Architectural Review Board Minutes July 19, 2023

Location 3 North Castle Drive, Armonk, NY 10504

Project Description Proposed 88 unit Townhouse development.

IBM DEVELOPMENT SITE | FRONT ELEVATION

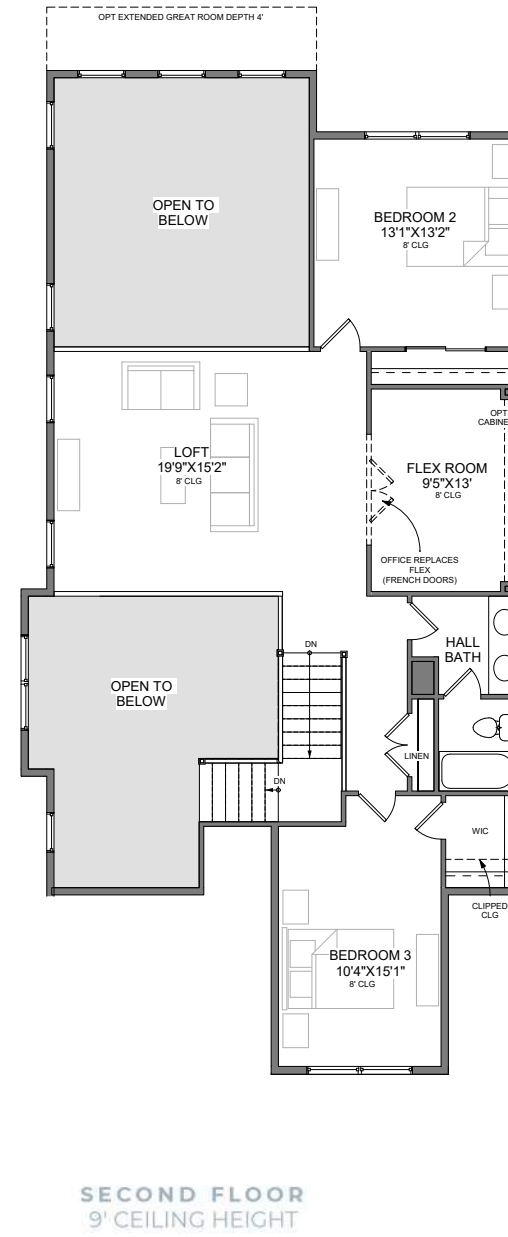
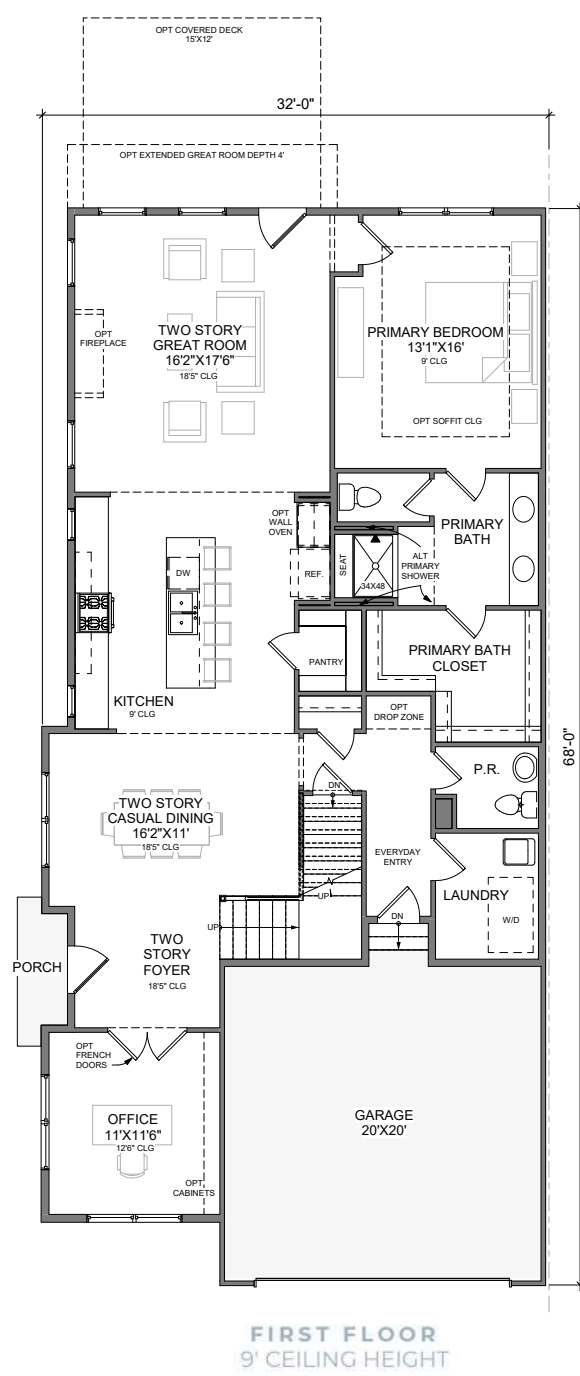
Remarks: This application was presented and reviewed by the Board for overall site plan, landscaping of units and common areas, (2) types of exterior designs and color schemes for exterior finishes. The modern farmhouse design was preferred with both the Walters and the Wilkerson designs. The colors picked will be white and black or gray and black. The customer will choose color scheme. The 8 required AFFH units were also discussed and reviewed as farmhouse “Clermonte” and color schemes and design also approved.
